Sansui Europe Service Information

SSI-0004E

Models : - 9090, 8080

FIG. 4

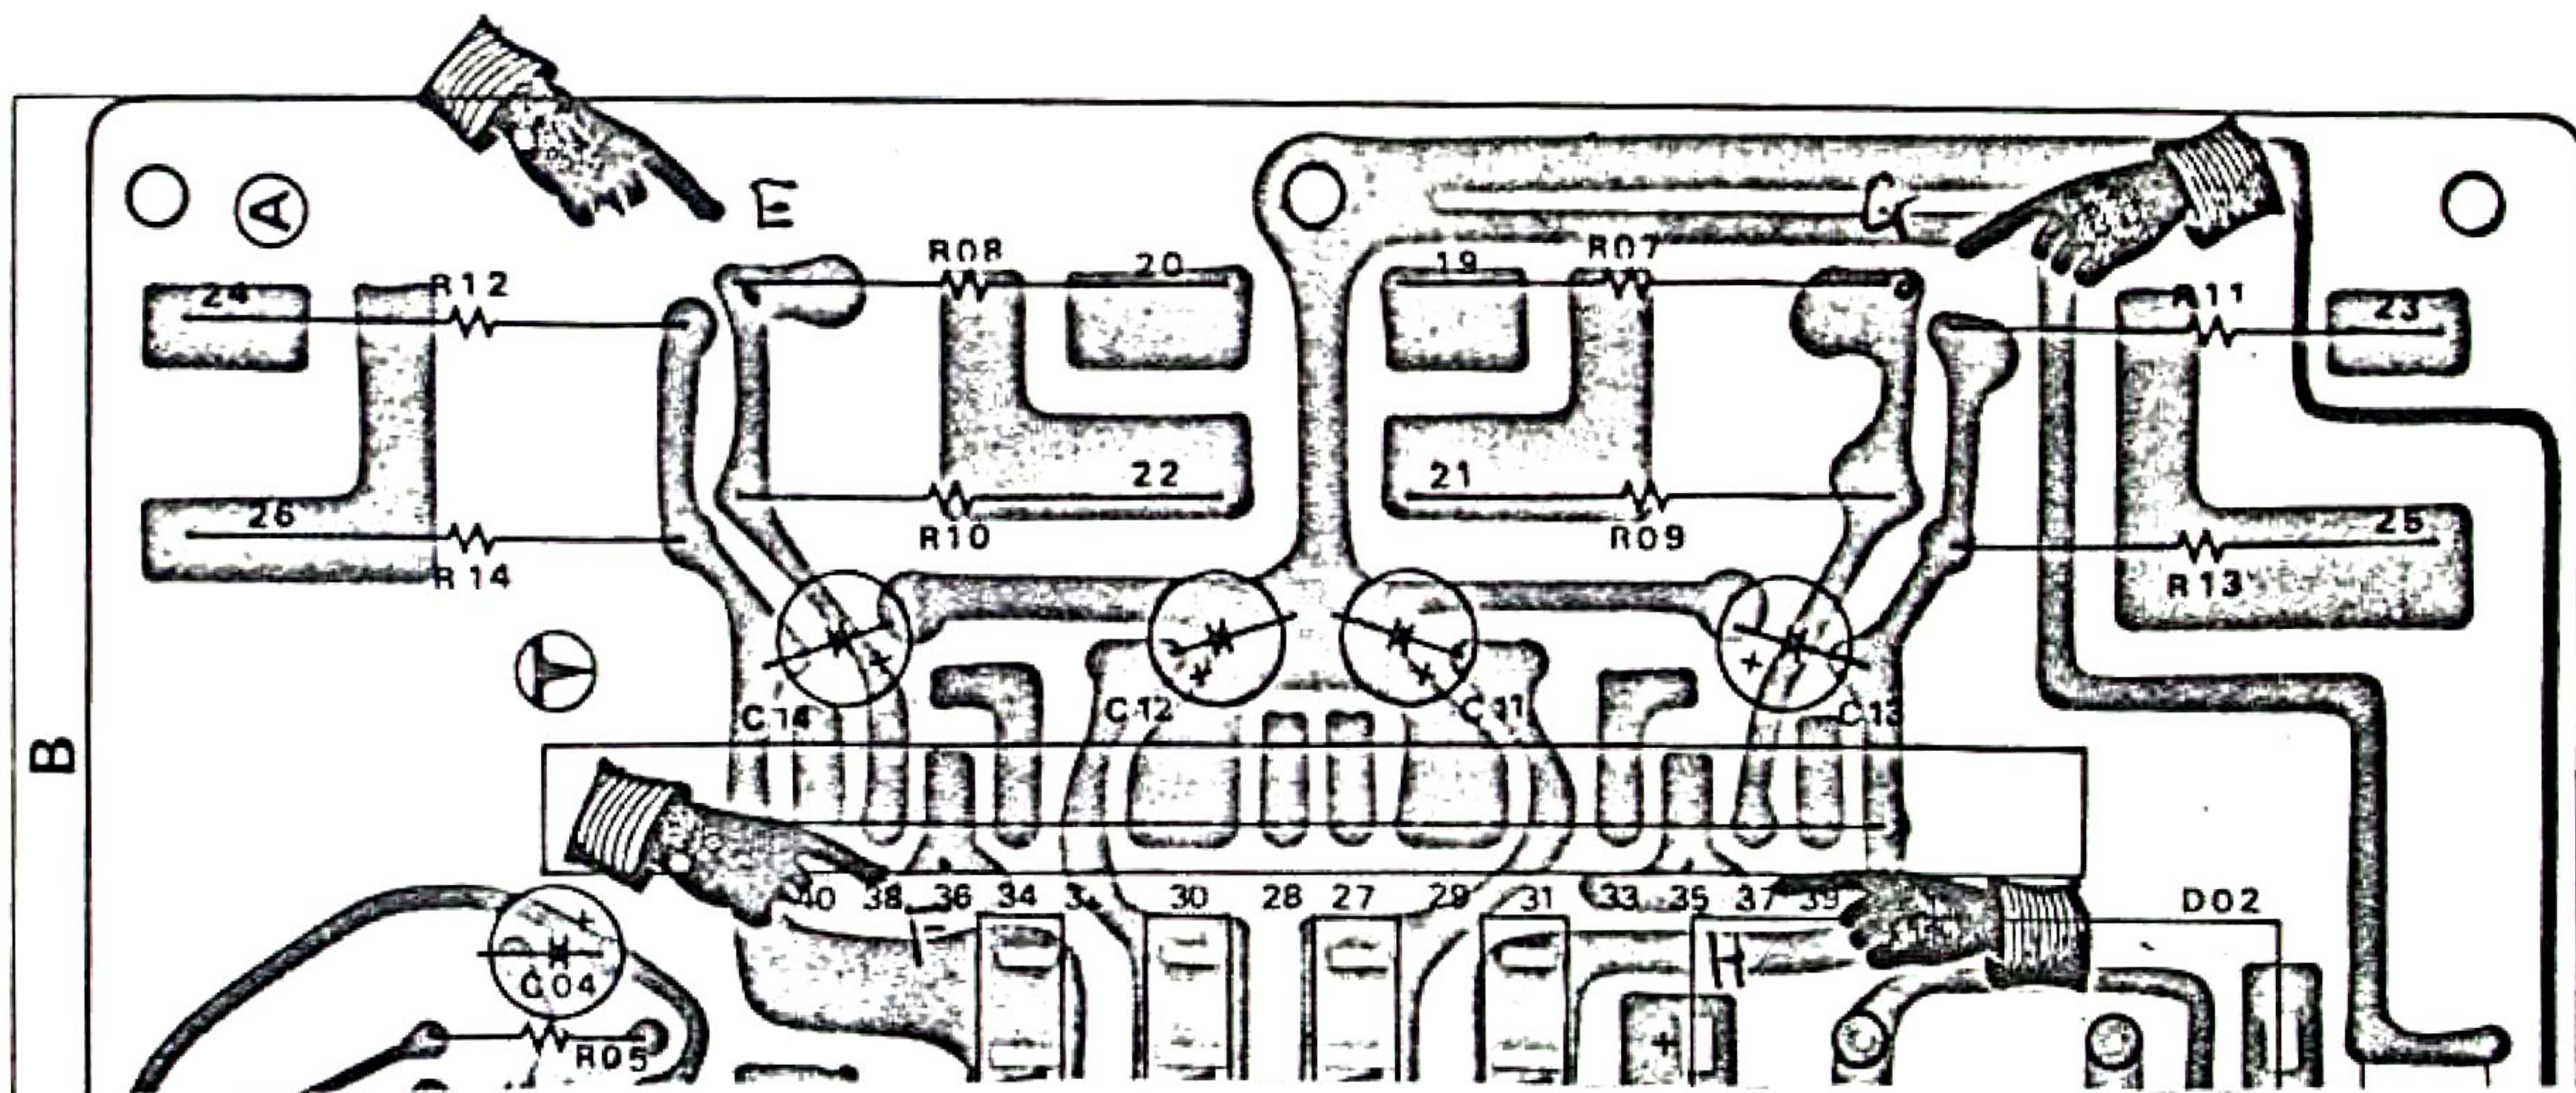
- It is also possible that these connections are made, like shown on fig. 4, from point E to point F and from point G to H. Even so these jumpers should be removed.
- Make the following connections with normal wire :
 - from point 04 on F-2547 to point 35 on F-2546
 - from point 03 on F-2547 to point 36 on F-2546
